Access Compliance Report

Public Rights-of-Way

(Curb Ramps)

Intersection ID: 19259	Main Street: VILLAGE_LAKE_DR	Cross Street: PEBBLESTONE_DR	Location: SE
ADA ID: 98930FA5E138	Ramp Type: PerpDiag	Initial Pass/Fail: Pass	Overall Compliance: No
		Severity Score: 15

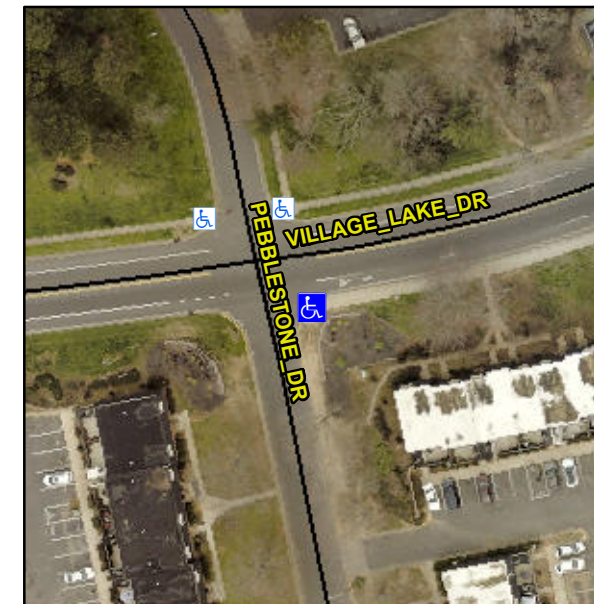
Not Found, R304.2.1, R304.2.2-Perp, R304.3.2-Para, R304.5.3, R304.5.4

Compliance	Description	Data	Compliance	Description	Data
N/A	Ramp Length (in)	85.0	Yes	Ramp Slope (%)	6.1
Yes	Ramp Width (in)	48.0	Yes	Ramp XSlope (%)	1.6
N/A	Flare Type LT	Sloped	N/A	Flare Type RT	N/A
N/A	Flare Slope LT (%)	1.3	Yes	Flare Slope RT (%)	3.5
N/A	Flare Traversable LT?	Yes	N/A	Flare Traversable RT?	Yes
No	Landing Length (in)	N/A	Yes	DWS Provided?	Yes
No	Landing Width (in)	N/A	Yes	DWS Contrast?	Yes
No	Landing Slope (%)	N/A	Yes	DWS Length (in)	24.5
No	Landing X Slope (%)	N/A	Yes	DWS Full Width?	Yes
N/A	Landing Curb? (Y/N)	No	Yes	DWS Offset (in)	0.0
N/A	Shared Landing?	N/A			
Yes	Gutter Ponding?	No	No	Gutter Slope (%)	8.6
Yes	Gutter Lip Ht (in)	0.0	Yes	Gutter X Slope (%)	0.1
N/A	Painted X Walk1?	No	N/A	Painted X Walk2?	No
	X Walk 1 Direction	To N		X Walk 2 Direction	To W
N/A	X Walk 1 Width (in)	N/A	N/A	X Walk 2 Width (in)	N/A
	X Walk 1 Slope (%)	4.5		X Walk 2 Slope (%)	4.0
	X Walk 1 X Slope (%)	5.5		X Walk 2 X Slope (%)	2.3

Remove & Replace Curb Ramp With Two New Directional Ramps or Equivalent. Remove & Replace Gutter.
